Model: H1		Date: 25-Jan-01	No.: RH538001a												
Subject: Service Manual Correction (H1)		Prepared by: A. Ishiyama													
From: Technical Services Dept., GTS Division															
Classification:

This RTB is to inform of mistakes in the service manual.

Model: H1		Date: 22-Aug-01	No.: RH538005
Subject: Paper Exit Tray Decals		Prepared by: A. Ishiyama	
From: Technical Services Dept., GTS Division			
Classification:	<input type="checkbox"/> Troubleshooting <input type="checkbox"/> Mechanical <input type="checkbox"/> Paper path <input type="checkbox"/> Other ()	<input checked="" type="checkbox"/> Part information <input type="checkbox"/> Electrical <input type="checkbox"/> Transmit/receive	<input type="checkbox"/> Action required <input type="checkbox"/> Service manual revision <input type="checkbox"/> Retrofit information

4.2.18 Software Download (Function 12)

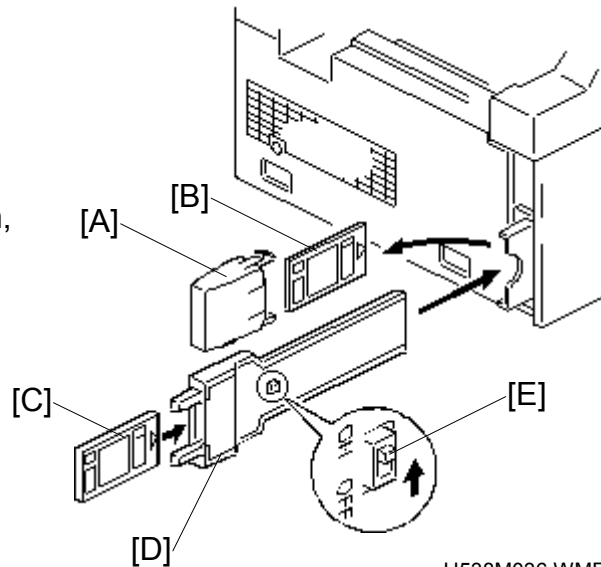
NOTE: When writing the software to the flash memory card, set the Start and End addresses as shown below.

START ADDRESS: 300000 (H), **END ADDRESS:** 3FFFFF (H)

NOTE: The switch on the copy tool [E] must be at the **ON** position.

1. EXTERIOR 1 (H538)

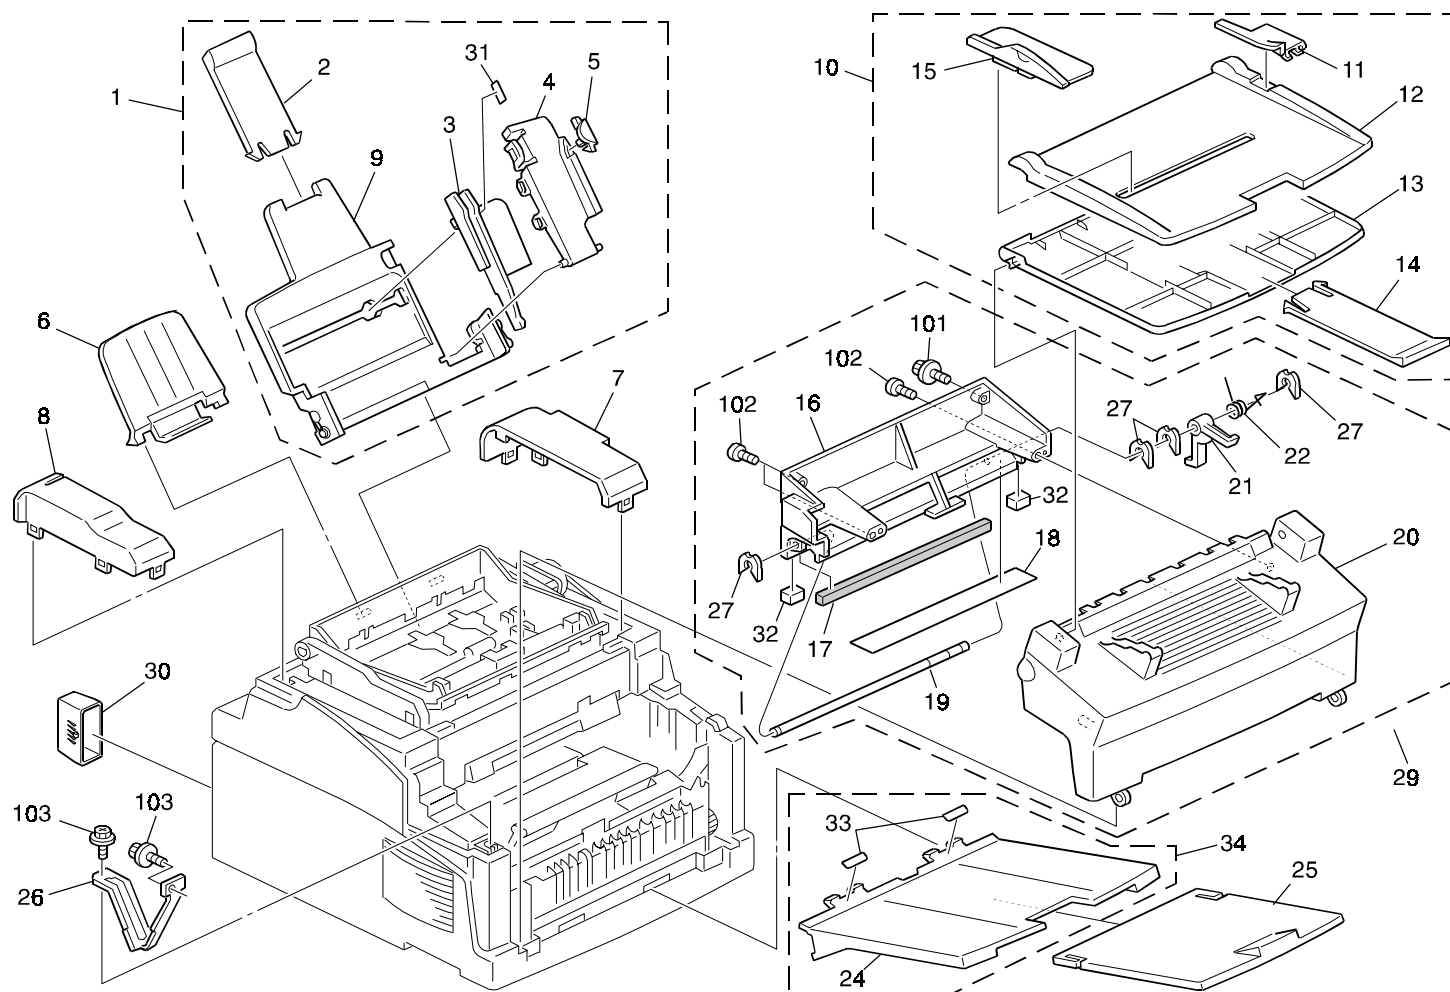
Paper jam at paper exit.

The pressure roller(s) at the paper exit are inadvertently pushed inside the machine when the user sets the paper exit tray, blocking the paper path.

The following changes have been made to clearly indicate to the customer where the exit tray should be attached:

1. Two types of directional arrow decals have been added (2 small decals for the tray, 2 large ones for the mainframe). Please refer to MB No.010 (MH538010) for details on service parts, P/N changes.
2. The Installation Procedure in the Installation Manual has been revised, using illustrations that clearly indicate the attachment positions.
